T-SB-0187-13

# Rear Suspension Clunk Noise

YEAR(S)	MODEL(S)	ADDITIONAL INFORMATION
2006 – 2012	RAV4

**Figure 1. Stabilizer Link Present**

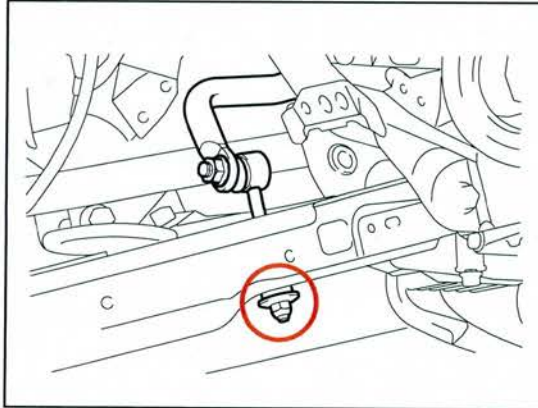
1. Place the vehicle on a lift and check for presence of the Stabilizer Link under the rear suspension arm No. 2.

2. If the Stabilizer Link is damaged on either side, remove the Stabilizer Link Assembly from the Stabilizer Bar on both sides by removing the nut at the Stabilizer Bar.
3. Discard the remaining Stabilizer Cushions if any are present
4. Install 2 NEW Stabilizer Link Assemblies. Make sure that both Stabilizer Cushion No. 1 and No. 2 are replaced as a set using both new part numbers as outlined in the Parts Information section.
